## **Historic Architectural Review Commission**

# Staff Report Item 4

**Application Number:** H14-01-1451

**Description of Work:** Demolition of non-historic rear additions.

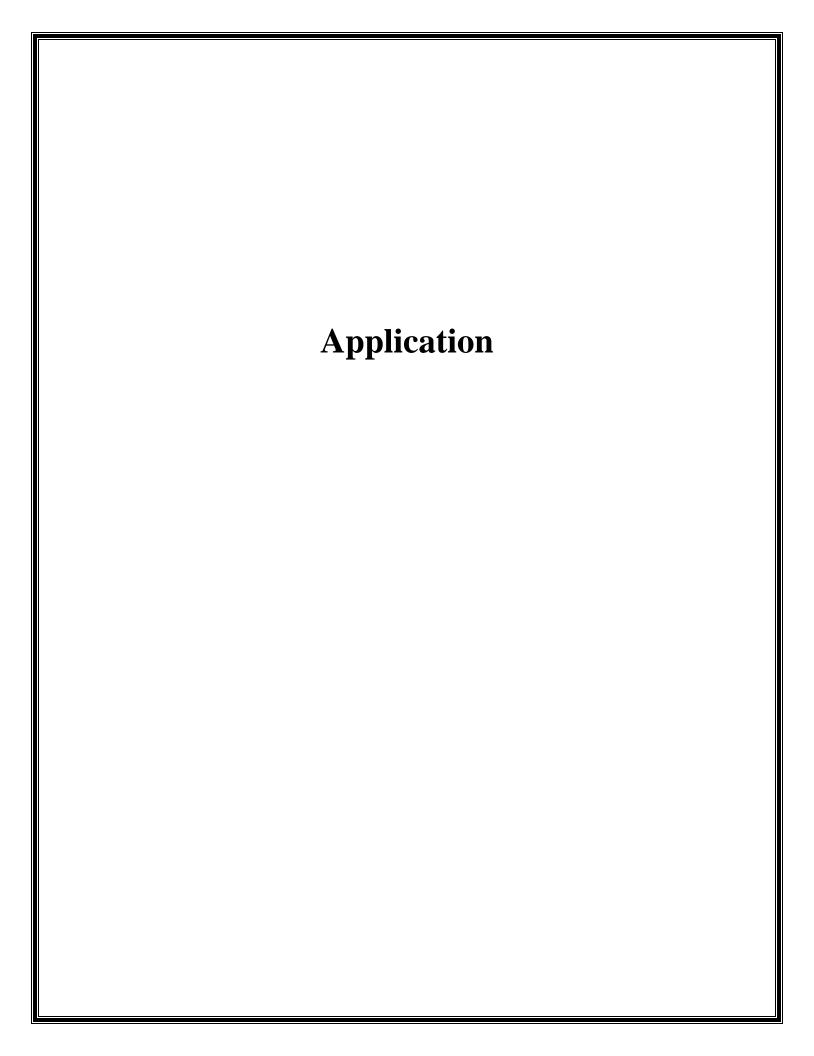
On October 8th, the Commission approved the proposed design for the rear addition and the first reading for a demolition request. This review is for a second reading request for demolition of the wall of the contributing building and the demolition of a historic addition. The addition in question was built

around the same time as the house and first appears on the 1912 Sanborn map.

It is staff's opinion that the demolition of the wall of the main house cannot be supported according to Section 102-217 (3) and Section 102-218 (a) (1). The wall, while modified, is not irreparably compromised by extreme deterioration. The historic addition on the other hand has been deemed non-contributing as staff does not feel it meets any criteria listed in Sec. 102-125 (1) through (9). If the Commission approves the demolition, this will be the final reading for this request.
